# CONTROLLED COPY

### 3/4.4.6 PRESSURE/TEMPERATURE LIMITS

# WNP-2 Pressure/Temperature limits

Figure 3.4.6.1

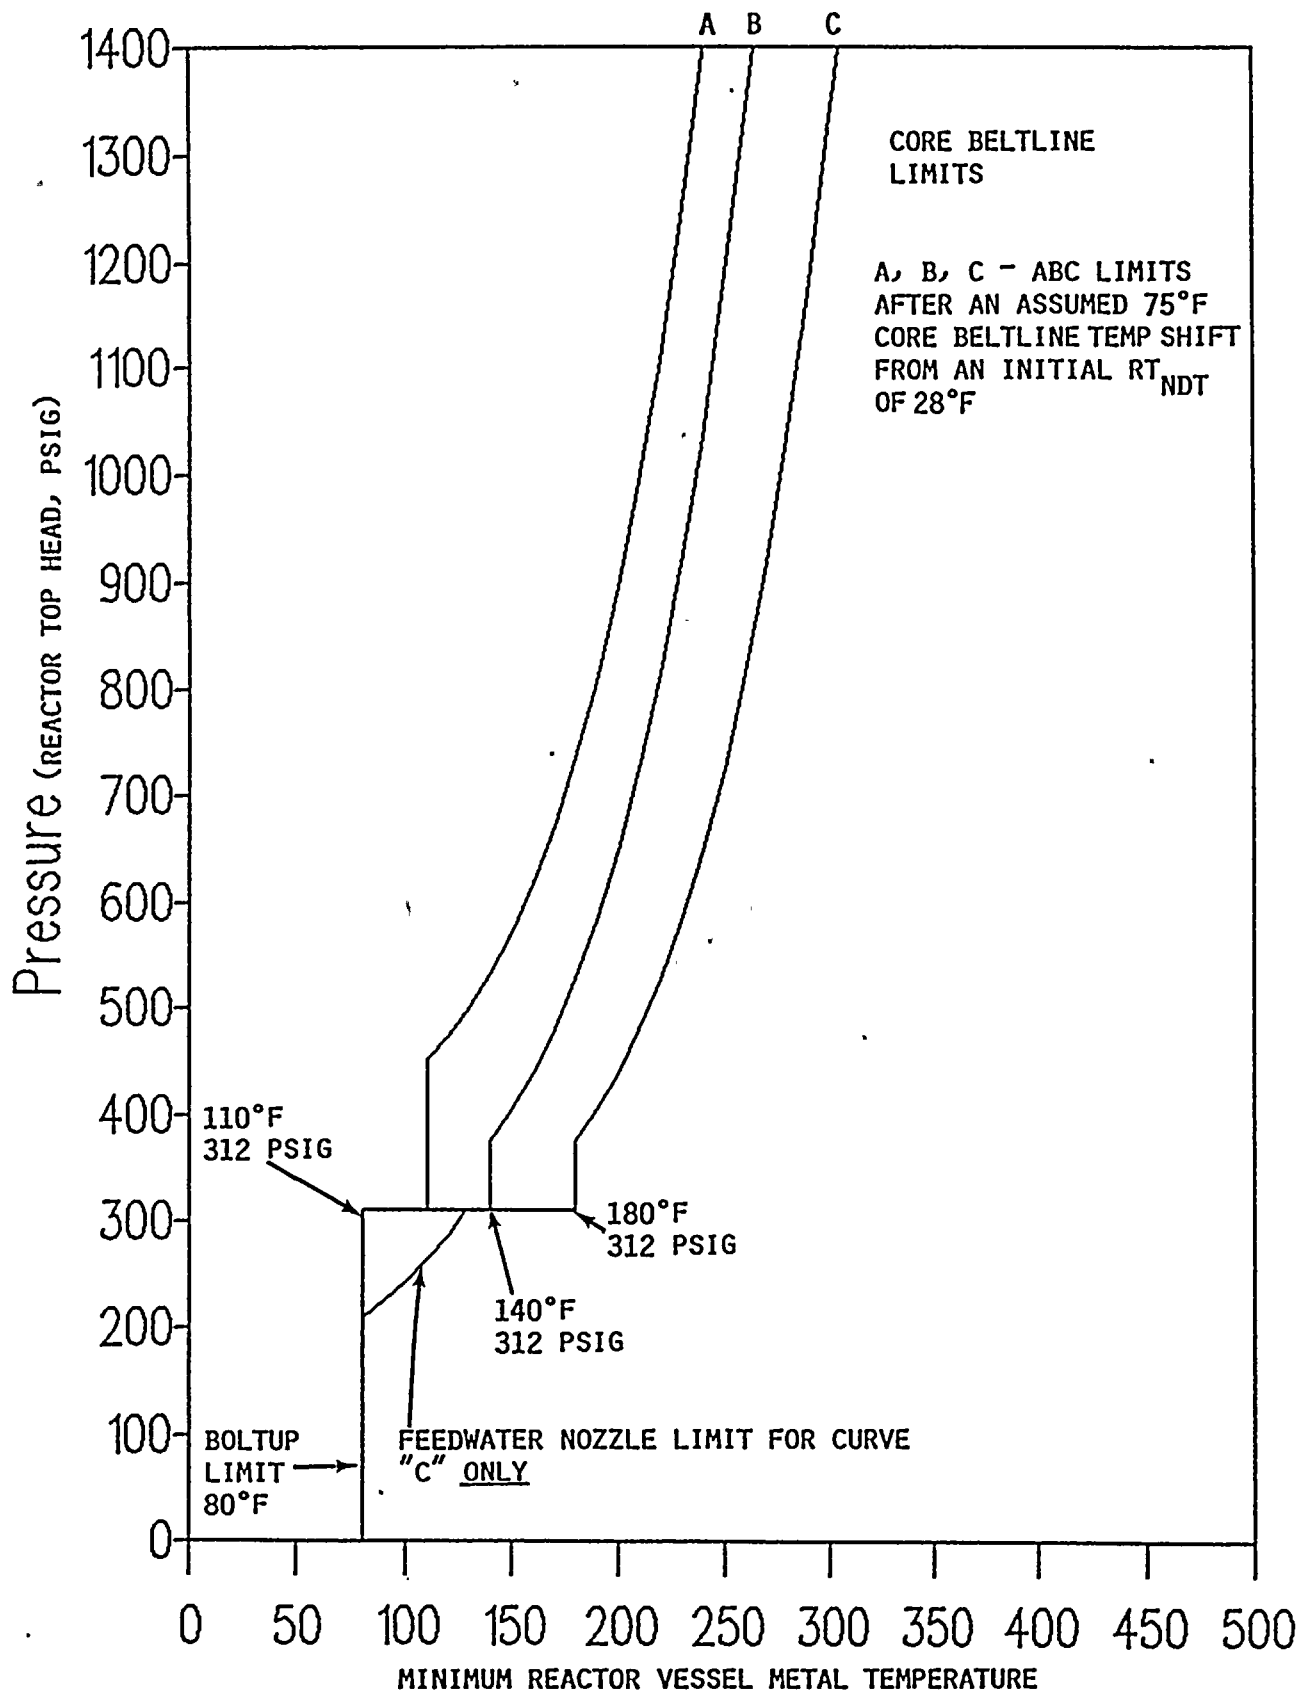
3.4.6.1 The reactor coolant system temperature and pressure shall be limited in accordance with the limit lines shown on Figures 3.4.6.1-1 and ~~3.4.6.1-2~~ (1) curves A and ~~A'~~ for hydrostatic or leak testing; (2) curves B and ~~B'~~ for heatup by non-nuclear means, cooldown following a nuclear shutdown and low power PHYSICS TESTS; and (3) curves C and ~~C'~~ for operations with a critical core other than low power PHYSICS TESTS, with:

4.4.6.1.1 During system heatup, cooldown, and inservice leak and hydrostatic testing operations, the reactor coolant system temperature and pressure shall be determined to be within the above required heatup and cooldown limits and to the right of the limit lines of Figures 3.4.6.1-1 and ~~3.4.6.1-2~~ curves A and ~~A'~~, B and ~~B'~~, or C and ~~C'~~, as applicable, at least once per 30 minutes.

4.4.6.1.2 The reactor coolant system temperature and pressure shall be determined to be to the right of the criticality limit line of Figures 3.4.6.1-1 and ~~3.4.6.1-2~~ curves C and ~~C'~~ within 15 minutes prior to the withdrawal of control rods to bring the reactor to criticality and at least once per 30 minutes during system heatup.

4.4.6.1.3 The reactor vessel material surveillance specimens shall be removed and examined, to determine changes in reactor pressure vessel material properties as required by 10 CFR Part 50, Appendix H in accordance with the schedule in Table 4.4.6.1.3-1. The results of these examinations shall be used to update the curves of Figures 3.4.6.1-1 and ~~3.4.6.1-2~~.
